**ASHLAND PLANNING COMMISSION  
HEARINGS BOARD  
AGENDA  
MARCH 11, 2008**

A. **PLANNING ACTION: *PA-2007-02151***

**SUBJECT PROPERTY: *938 Oak St.***

**ASHLAND PLANNING DEPARTMENT  
STAFF REPORT  
March 11, 2008**

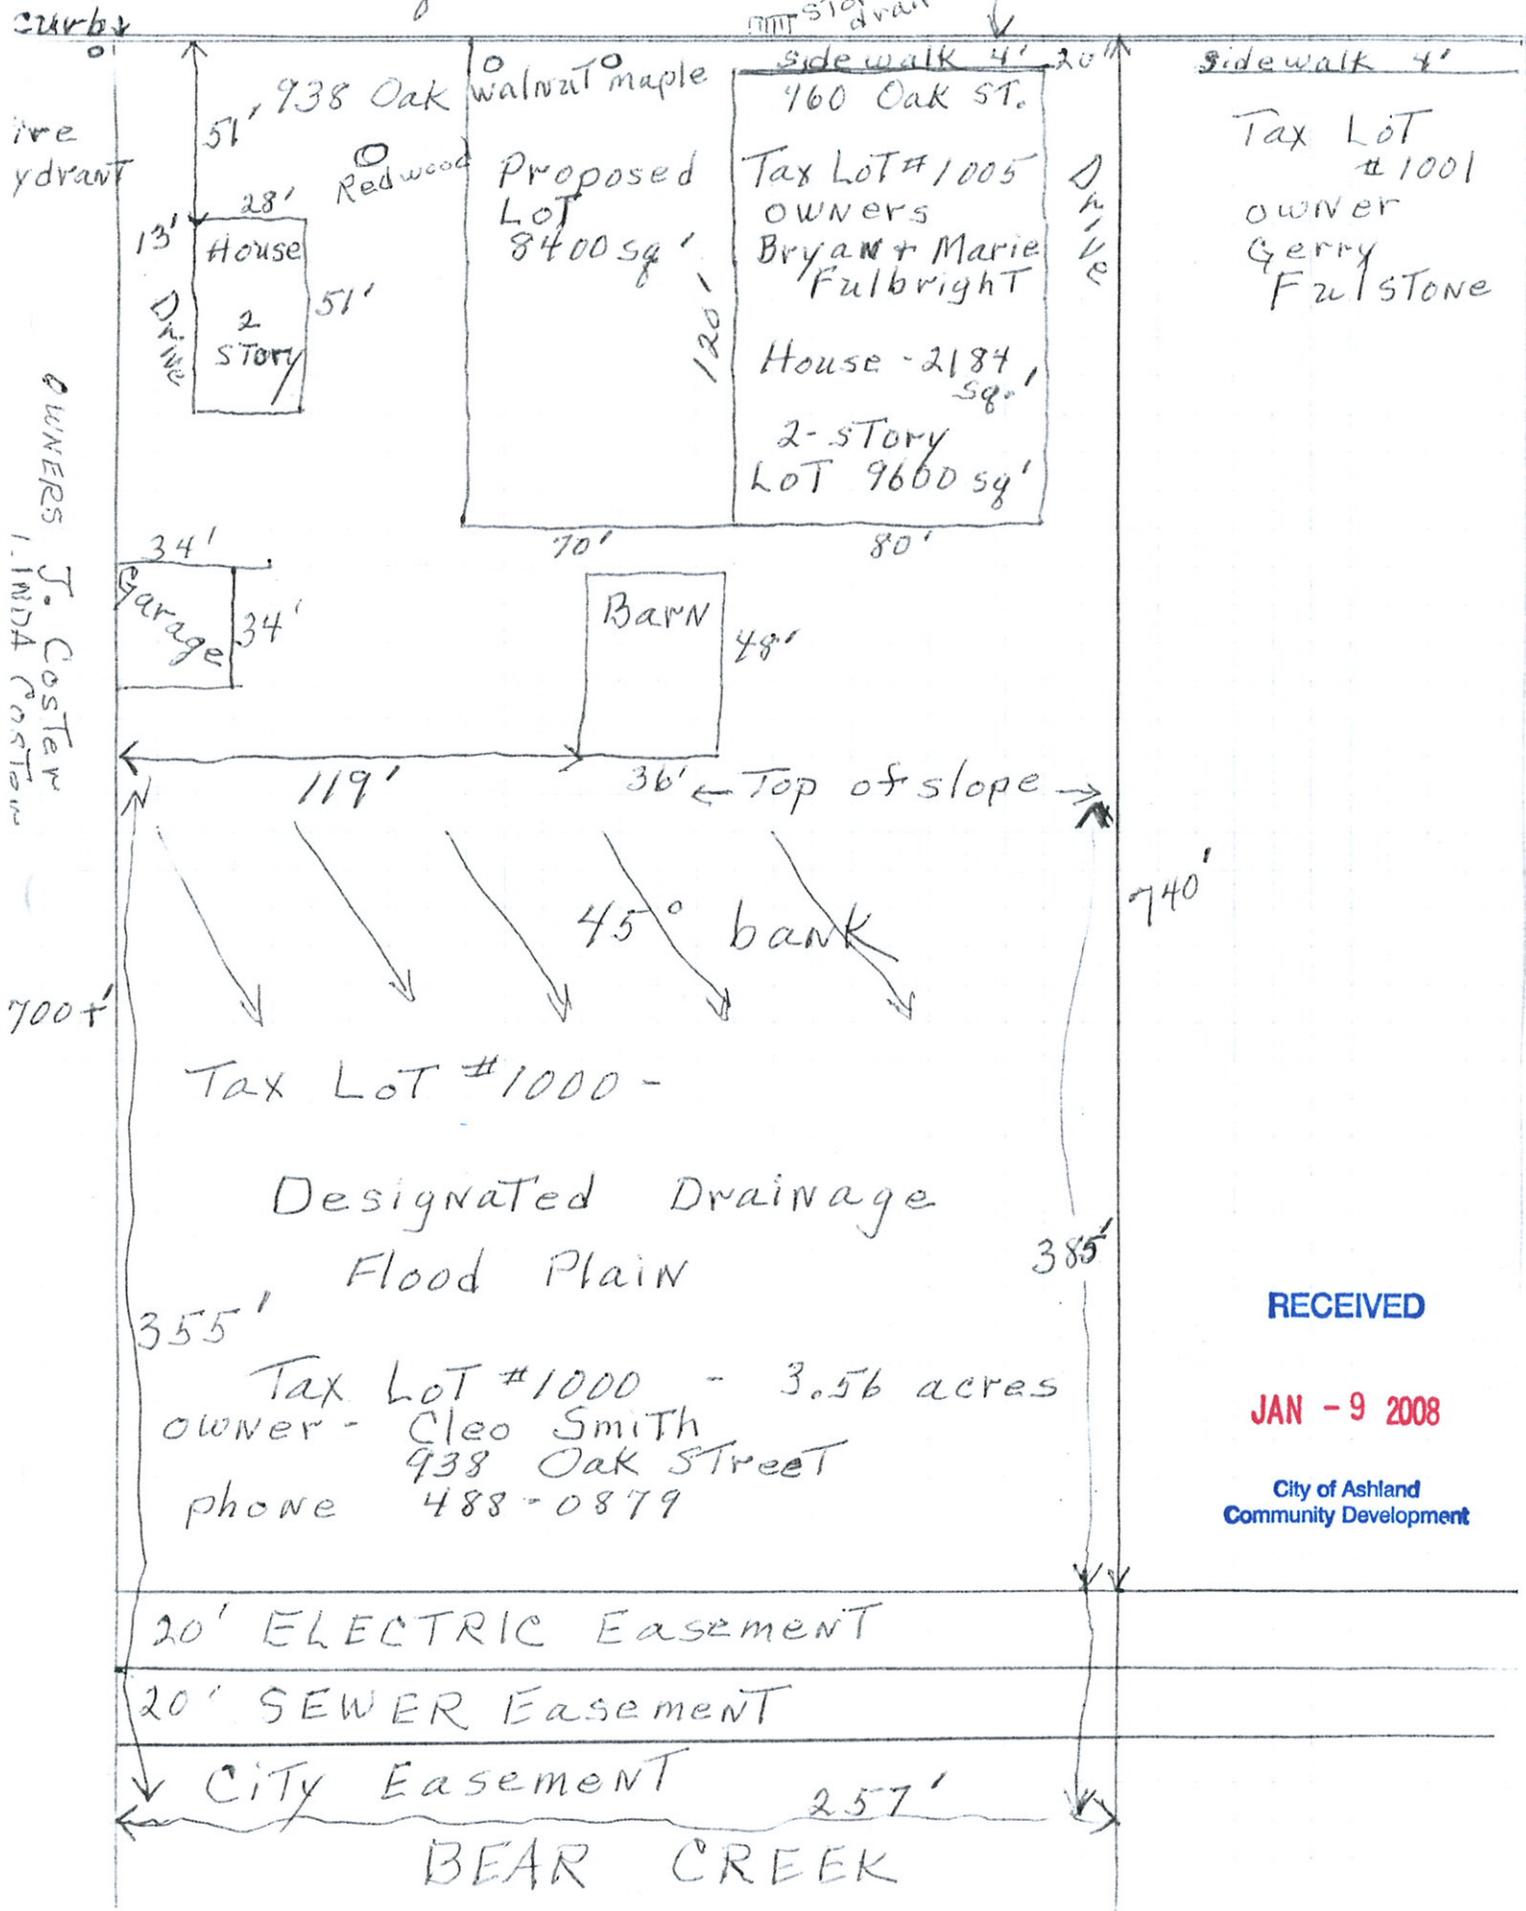
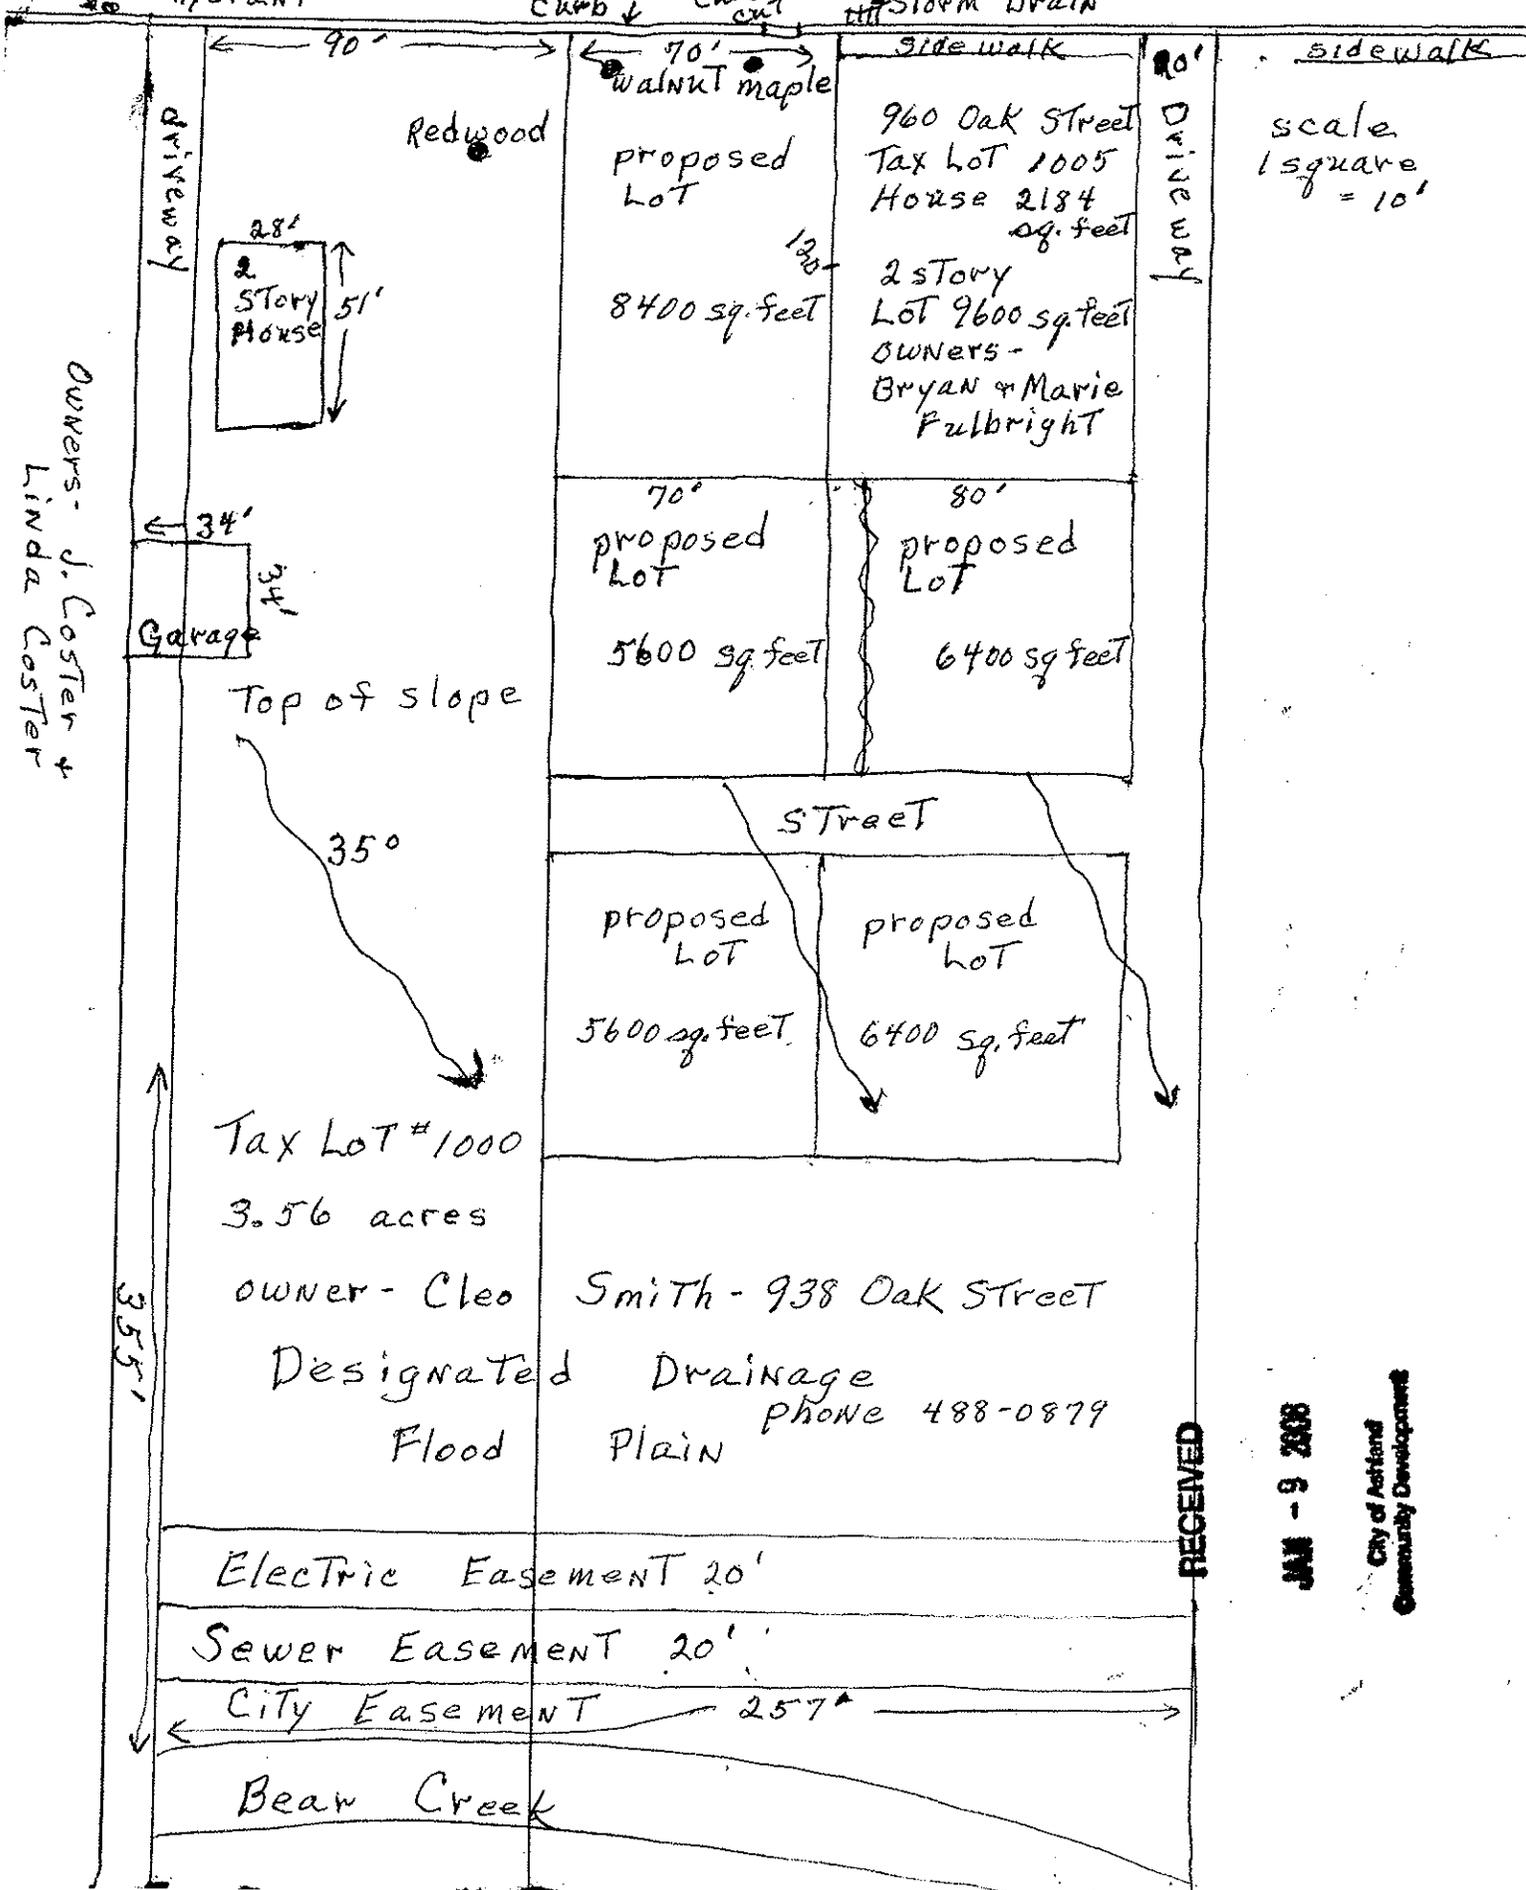
The applicants have provided a plan for further development of the property with this application, but it does not conform to current development code requirements. The future development plan shows a 20 foot driveway connecting to a 20 foot public street as the future access to the remainder of the parcel, which would not provide adequate width for a public right-of-way. (The 20 foot driveway shown would be a 40-foot public street if developed, based on the previous dedication of property described above.) Flood plain and Drainage Easement locations are not accurately depicted, and areas of slope are not addressed either. For these reasons, the development plan submitted does not conform to City of Ashland standards and should not be approved as part of the submitted application.

- **Solar Setback Compliance** should be verified prior to signature of the final plat.
- **Future Development Plan** does not meet City of Ashland standards for streets and does not address the physical constraints of the lot. Approval of the land partition should not be interpreted as an approval of the concepts presented in this plan. At such time as the lot were to be further developed, a new plan must be created to address subdivision requirements of the Performance Standards Options Chapter of the Development Code.

- 3) That the Future Development Plan submitted by the applicant is not approved as part of this action. Any further development of the lot will require a new plan to be submitted.
